# **Response to Request for Additional Information**

Sydney Metro City & Southwest

**Crows Nest Over Station Development –  
Modification Application (SSD 9579 MOD 1)**

Figure 1: Swept path assessment of Clarke Lane lay-by

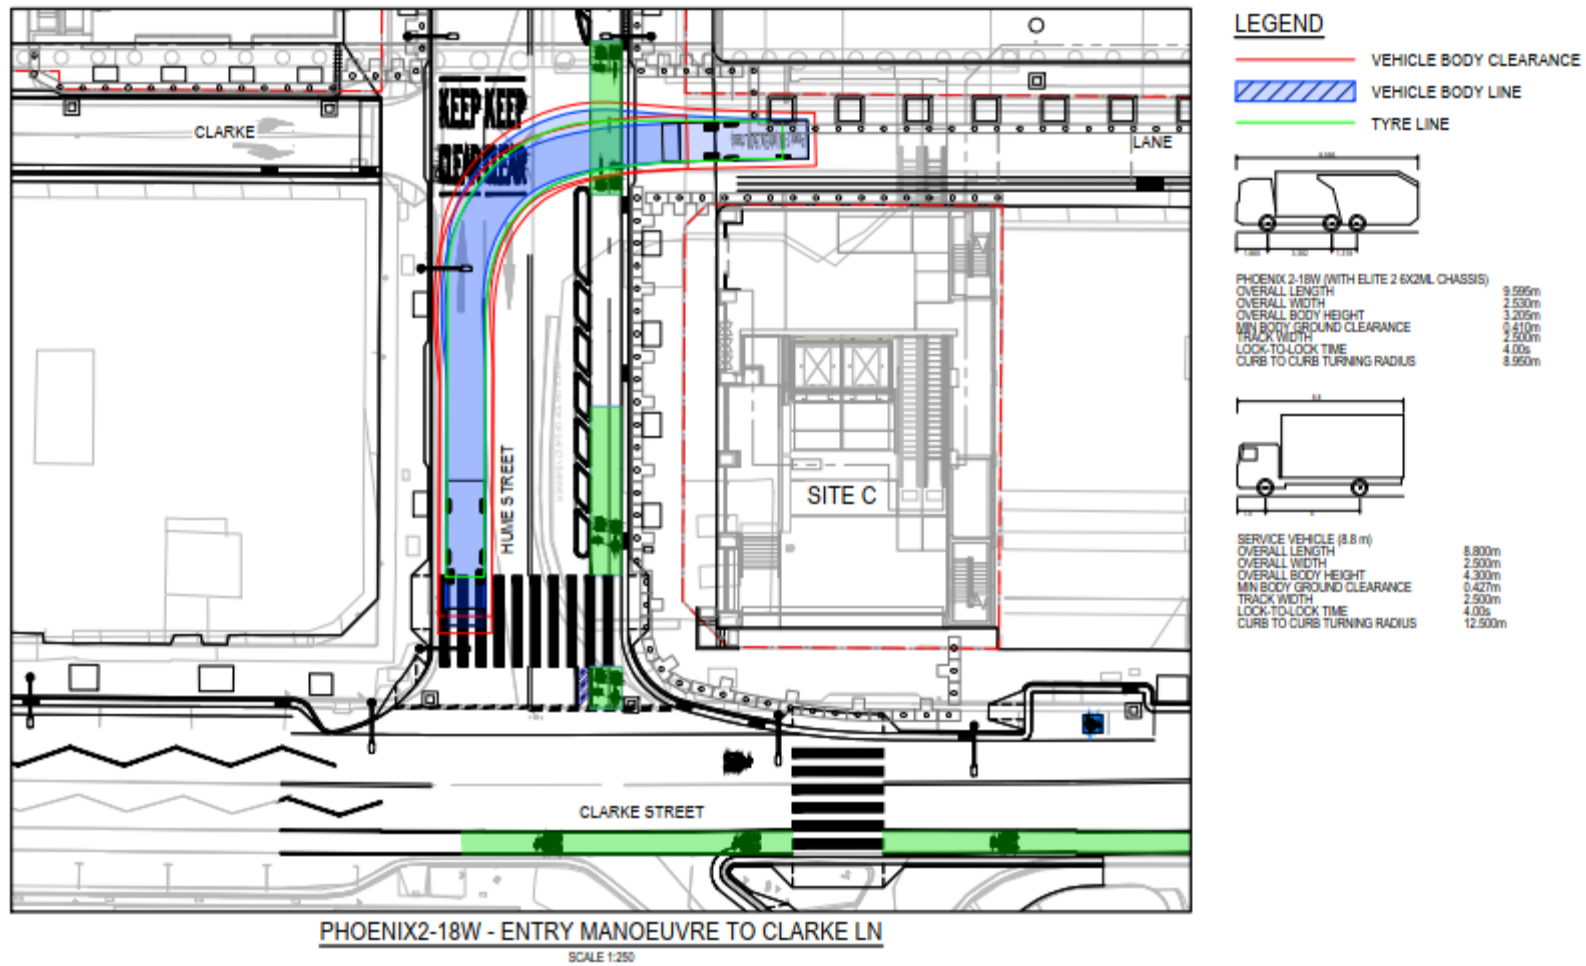
| Extract   | Response  |
|---|---|
| However, Council remains concerned regarding the safety and efficiency of maintaining the truck lay-over space in Clarke Lane, despite being included in the original approval. | <p>Noted. This arrangement was assessed in detail and found to be appropriate as part of the Concept SSD Approval. It is not a relevant consideration under this Modification Application.</p> <p>Nevertheless, we note that the safety and efficiency of the lay-by was extensively discussed in the Concept SSD Approval Traffic Statement dated November 2018. This included the preparation of detailed swept path assessments confirming no adverse operational impacts (refer to <b>Figure 1</b>)</p> <p>As identified in the Traffic and Transport Assessment Report for the Detailed SSD Application for the Site C OSD, deliveries will be encouraged during off-peak hours to minimise any interference with pedestrian and vehicle flows. This would likely avoid the need for delivery vehicles crossing of the footpath near a busy Metro rail station and is considered appropriate for the Site C OSD, which is a small commercial building.</p> |
